Make a Planning Appeal

Planning authority Kildare County Council

Planning authority register reference number 25/61119

RE: Third party appeal against decision of Kildare County Council

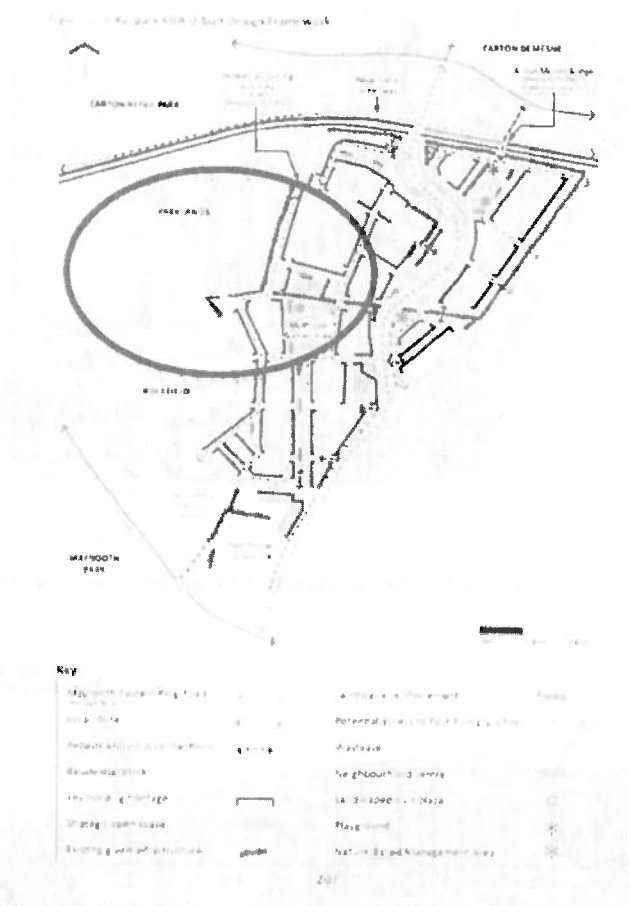
Despite the removal of PERM 61, the planning application continues to refer to a potential future pedestrian connection through Parklands Lawns. The Parklands Residents Association submission notes that *Figure 11.6 of the adopted Local Area Plan* shows the permeability routes intended to serve the Railpark Key Development Area.

No pedestrian, cycle or vehicular connection between Railpark and Parklands Lawns is shown on this map. In simple terms, the adopted Local Area Plan does not provide for a connection at this location.

The Parklands Residents Association believe that any inclusion of routes through Parklands Lawns in the current planning application or any forthcoming planning application would constitute a material contravention of the Maynooth and Environs Joint Local Area Plan 2025 – 2031.

The Board is respectfully requested to amend the permission by removing all references to any existing or future pedestrian or cycle connection through Parklands Lawns and to ensure that the development fully complies with the adopted Local Area Plan.

The Grange Ref: 25/60231

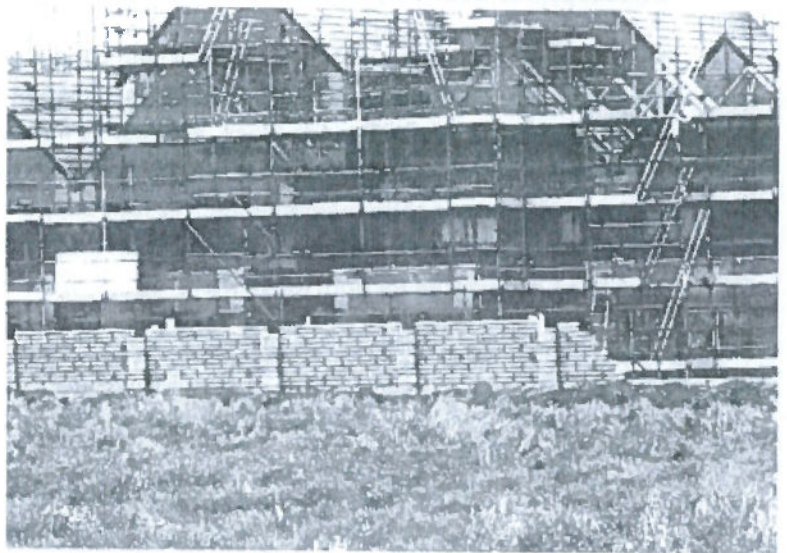
A recent example within County Kildare, The Grange (Ref: 25/60231), developed by Randalswood Construction is currently constructing a solid boundary wall between their development and the adjoining Rockfield estate. This demonstrates that a more durable, visually appropriate, and higher quality boundary treatment is both achievable and already implemented in similar residential contexts. We believe this sets a clear precedent and should be considered as a more suitable approach for the Railpark development.

The Board is respectfully requested to amend the permission by requiring the retention and protection of the existing hedgerow together with the construction of a permanent solid, capped and plastered boundary wall along the Parklands boundary. This would provide a clear and durable separation between existing homes and the proposed development and would better protect the privacy, security and residential amenity of adjoining residents in accordance with the Development Plan.

Another example is between Ard Rath and Crodaun in Celbridge.

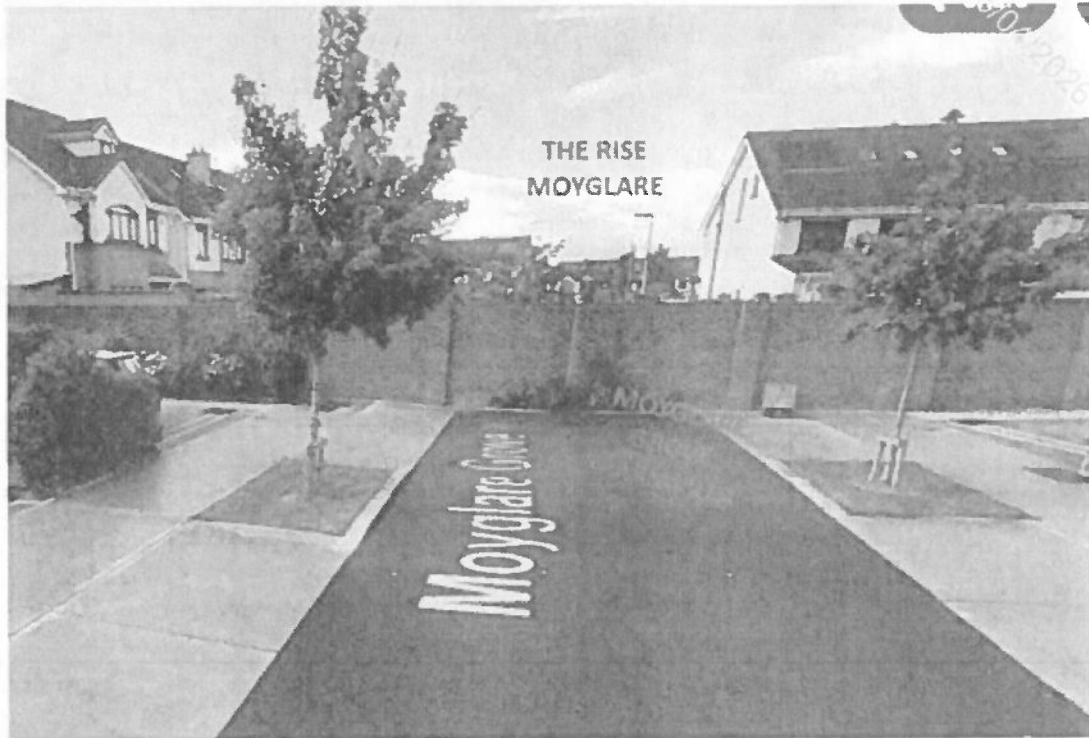
WALL

Another example is between The Rise Moyglare and Moyglare Grove Mariavilla.

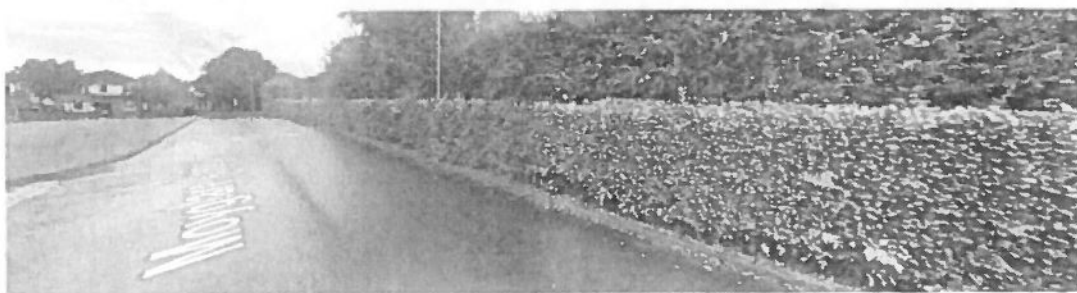
Between Moyglare Village and Moyglare Abbey. Please note the Boundary wall is located behind the hedge.
